SUBJECT: TRAFFIC METHODOLOGY APPROVAL LETTER

PROJECT NAME: ENCLAVE HOUSING CR 42 TRAFFIC IMPACT STUDY

Subject: Proposed Methodology for Enclave Housing CR 42

RE: Enclave Housing CR 42 Response to Comments

Figure 2. Project Trip Distribution

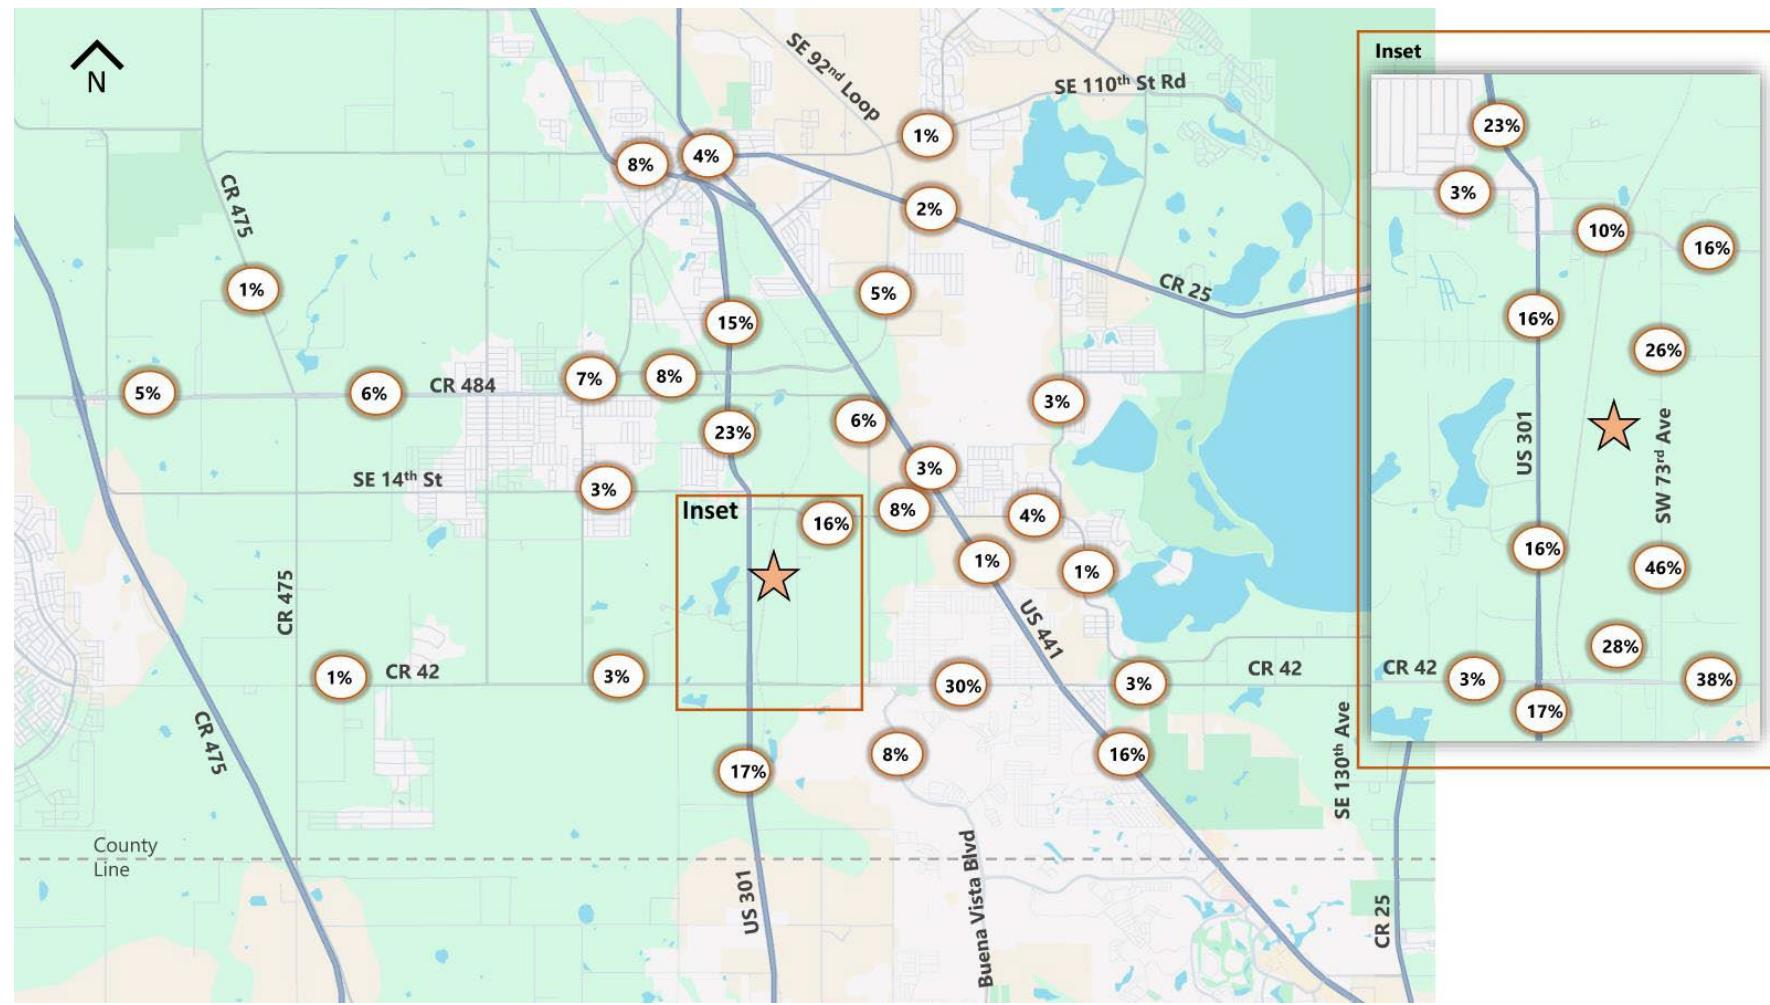
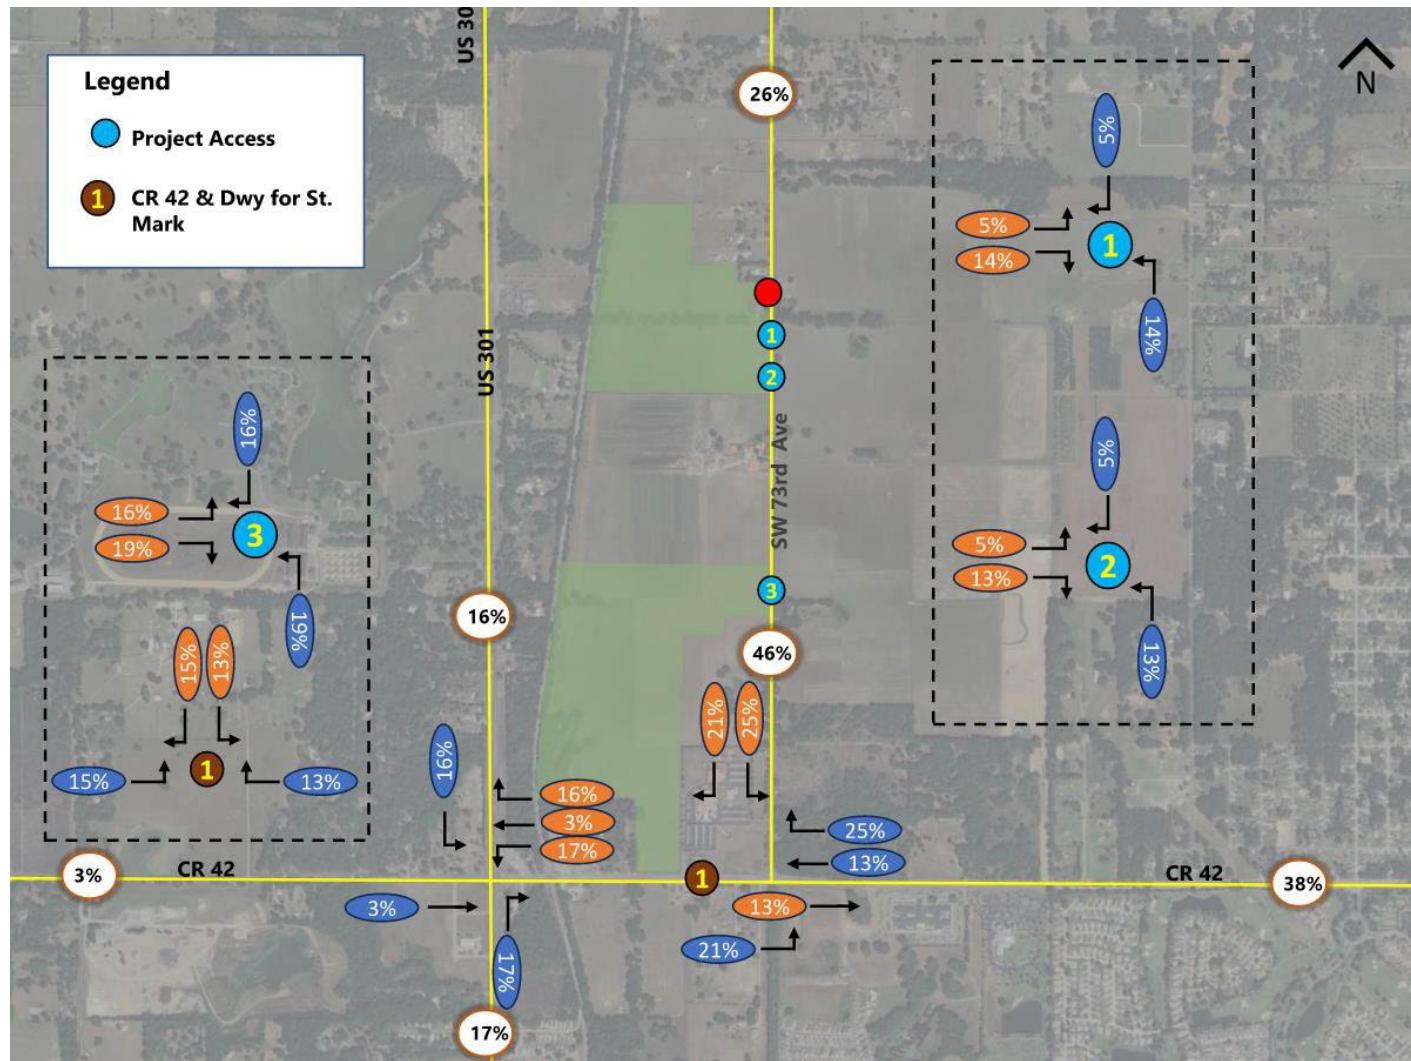
2. PDF pg. 4 & 5, Figures 2 & 3 - Figures 2 & 3 show different distributions to/from the south on SE 73rd Ave. Figure 2 shows 54% while Figure 3 shows 39%. Update the figures to show the same distributions on SE 73rd Ave. Ensure the distributions used in Table 2 also match the distributions shown on Figures 2 & 3.

Response: Agreed, and Figures 2 & 3 are updated accordingly.

Figure 3. Project Trip Distribution at Project Driveways

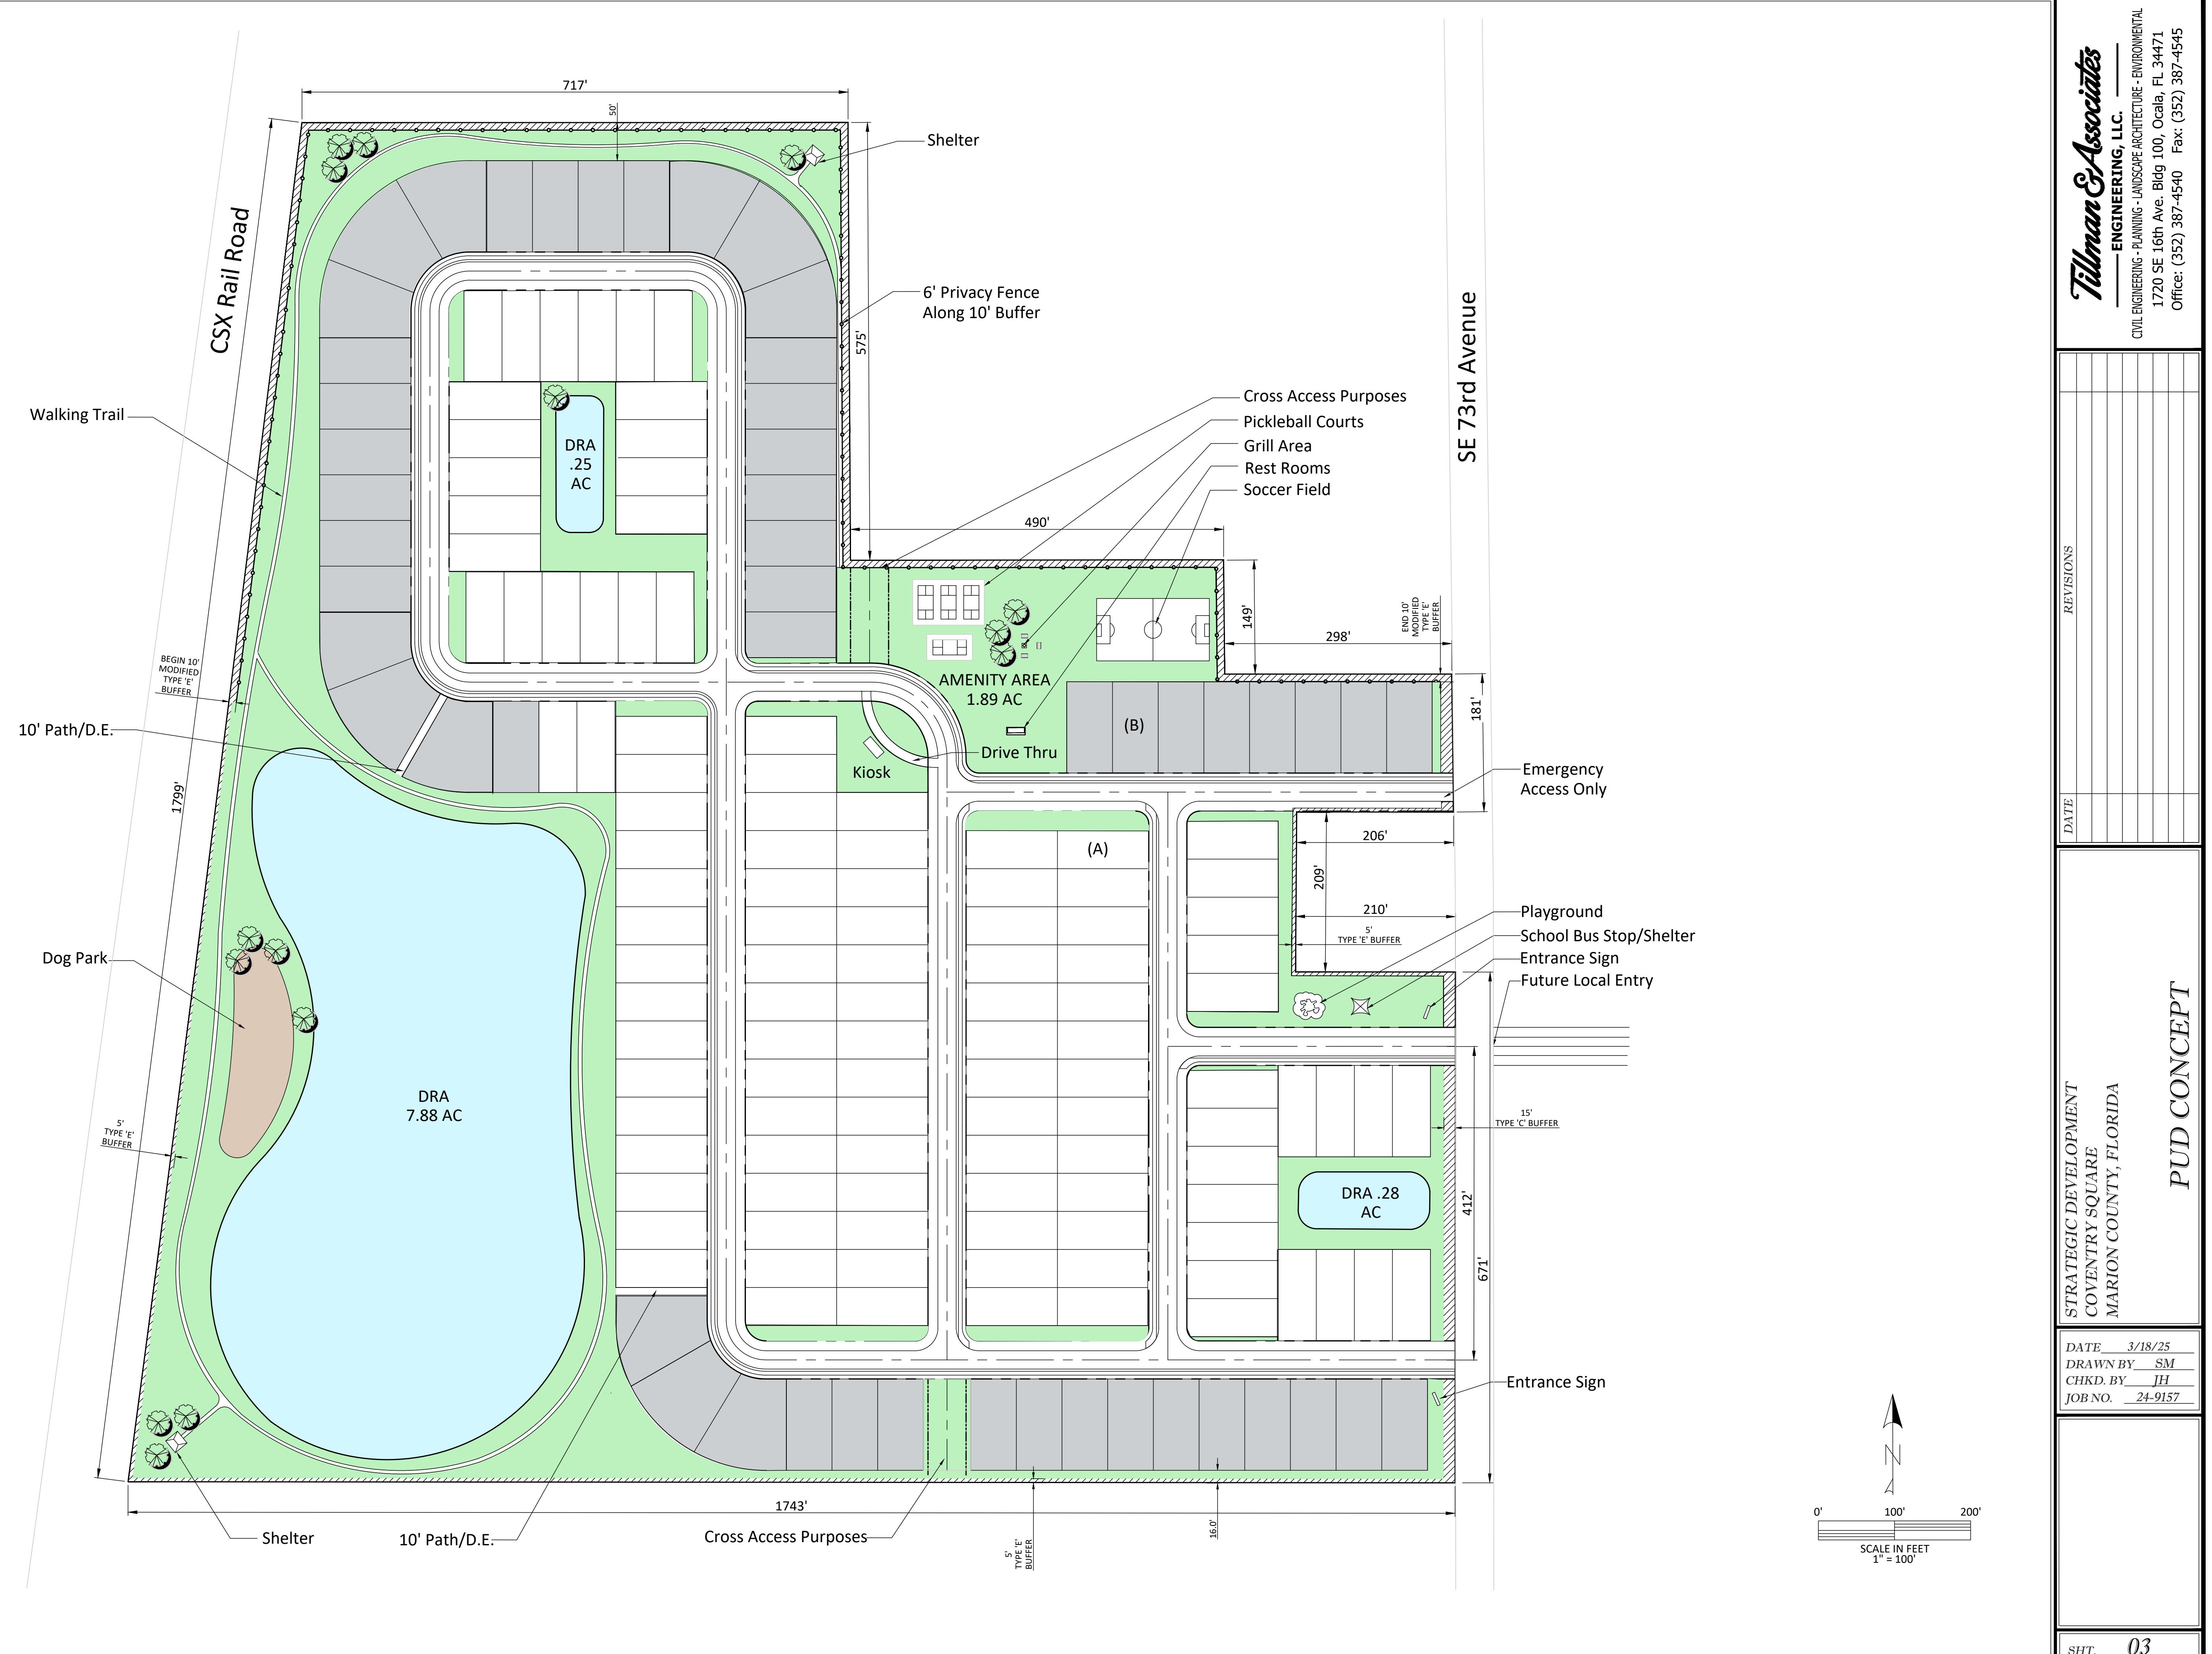
4. PDF pg. 5, Figure 3 - The 39% to/from the south on SE 73rd Ave needs to be changed to 46% based on the distributions shown at the driveways on SE 73rd Ave

5. PDF pg. 5, Figure 3 - The 15% of eastbound through traffic on CR 42 at SE 73rd Ave needs to be changed to 13%.

Response: Figure 3 has been updated to show 46% to/from the south on SE 73rd Ave.

Response: Figure 3 has been updated to show 13% eastbound through traffic on CR 42 at SE 73rd Avenue.
